## SUNDRY NOTICES AND REPORTS ON WELLS

8. Well Name and No.
PITCHBLENDE 19 FED COM 1H

# Pitchblende 19 Fed Com #1H
## Red Hills
## Lea County, New Mexico
## Revised 5/17/12
## Proposed Wellbore

**Pitchblende 19 Fed Com 1H**
**30-025-40435**
**EOG Resources**
**Conditions of Approval**

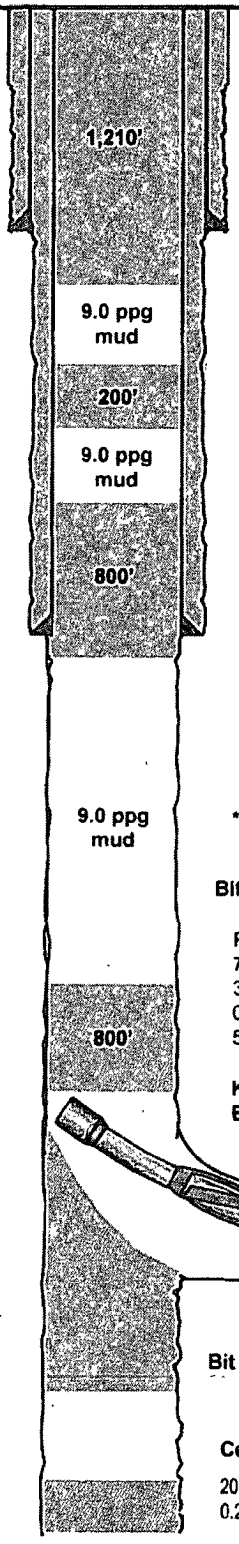
1. Ok. (Tag at 7812' or shallower). Plug 1 and 2 shall be less that 2000' apart.
2. Ok. (Tag at 5120' or shallower).
3. Ok. (Plug added due to min 3000' spacing between plugs in cased hole).
4. Ok. Install dry hole marker.
